# UNITED STATES PATENT AND TRADEMARK OFFICE

10/565,332

Peter Rippl

<b>Office Action Summary</b>	<b>Application No.</b> 10/565,332	<b>Applicant(s)</b> RIPPL, PETER	
	<b>Examiner</b> HUNG NGUYEN	<b>Art Unit</b> 3742

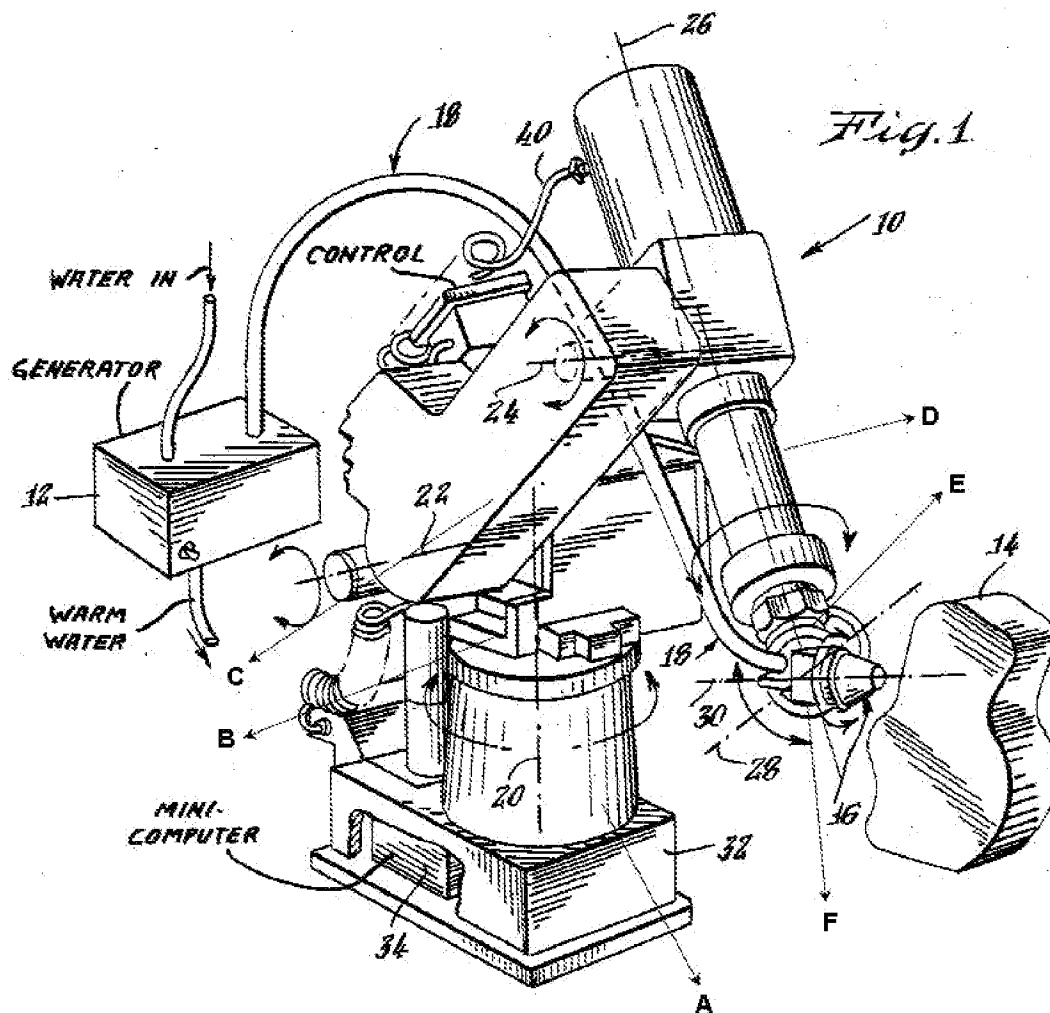
3. Regarding claims 1 and 14, Coulter discloses a machining workpiece with a moving laser beam, the process comprising: holding a laser tool 16 (Fig. 1) that emits the laser beam by a multiaxial mechanical manipulator A, B, C, D and E (Fig. 1, Illustrated below) at a manipulator hand E (Fig. 1, Illustrated below) at a spaced location above the workpiece 14 (Fig. 1, Illustrated below); moving the laser tool along a predetermined path along the workpiece (Abstract) by a displacing motion of the manipulator D (Fig. 1, Illustrated below) and during the displacing motion of the manipulator; and superimposing a compensating motion of the laser beam to the displacing motion during the displacing motion with the compensating motion being at least partially oppositely directed to the displacing motion.

4. Regarding claim 2, Coulter discloses a workpiece 14 (Fig. 1, Illustrated below) is machined intermittently, while machining phases and transport phases alternate (Arm C, Fig. 1 Illustrated below), wherein the point at which the laser beam reaches the

surface gets ahead of the laser tool (Fig. 1, Illustrated below, Shows the laser beam reaches the surface gets ahead the laser head, therefore as the arm D, Fig. 1, Illustrated below, moves upward by the "24" axis with respect to the workpiece, the robot arm C must move downward "22" axis to keep the constant distance from the workpiece; as the laser head pointed upwardly to the workpiece, the laser beam reaches to the surface ahead of the laser head).

5. Regarding claims 3 and 23, Coulter discloses at least partially transversely directed compensating motion of the laser beam is superimposed to the displacing motion during the machining operation. (Arm D Fig. 1, Illustrated below, movement same as compensating motion, is superimposed to the arm C Fig. 1, Illustrated below, movement same as displacement motion, to do the seam welding).

6. Regarding claim 6, Coulter discloses the compensation motion of the laser beam is an angular motion (Arm D, Fig. 1, Illustrated below, moves with "24" axis).

7. Regarding claim 7, Coulter discloses the compensating motion of the laser beam is performed by a pivoting motion of the manipulator hand about one of its hand axis D (Fig. 1, Illustrated below).

8. Regarding claim 10, Coulter discloses the laser beam is directed toward the workpiece at the beginning of machining with an obliquely forwardly directed beam angle  $\alpha$ ,  $\alpha'$  (Arm D Fig. 1, Illustrated below) swings up about "24" axis", with an angle and start the welding downwardly back to the horizontal position).

angle  $\beta$ ,  $\beta'$  (Arm D Fig. 1, Illustrated below, swings down about "24" axis", with an angle and start the welding upwardly back to the horizontal position).

10. Regarding claim 12, Coulter discloses the manipulator 110 (Fig. 1, Illustrated below) performs an essentially constant displacing motion (axis "28" Fig. 1, Illustrated below) during the machining.

11. Regarding claim 13, Coulter disclose the manipulator 10 (Fig. 1, Illustrated below) performs an essentially constant displacing motion during the transport phases between the machinings; arm C (Fig. 1, Illustrated below) needs to move for welding one spot to another.

12. Regarding claim 15, Coulter discloses the manipulator 10 (Fig. 1, Illustrated below) has a multiaxial manipulator hand A, B, C, D, E, F (Fig. 1, Illustrated below) in which at least one said hand axis 28/30 (Fig. 1, Illustrated below) can be controlled independently from the displacing motion.

14. Regarding claim 21, Coulter discloses the manipulator 10 (Fig. 1, Illustrated below) is designed as a, at least six-axis 20, 22, 24, 26, 28 and 30 (Fig. 1, Illustrated below) articulated-arm robot.
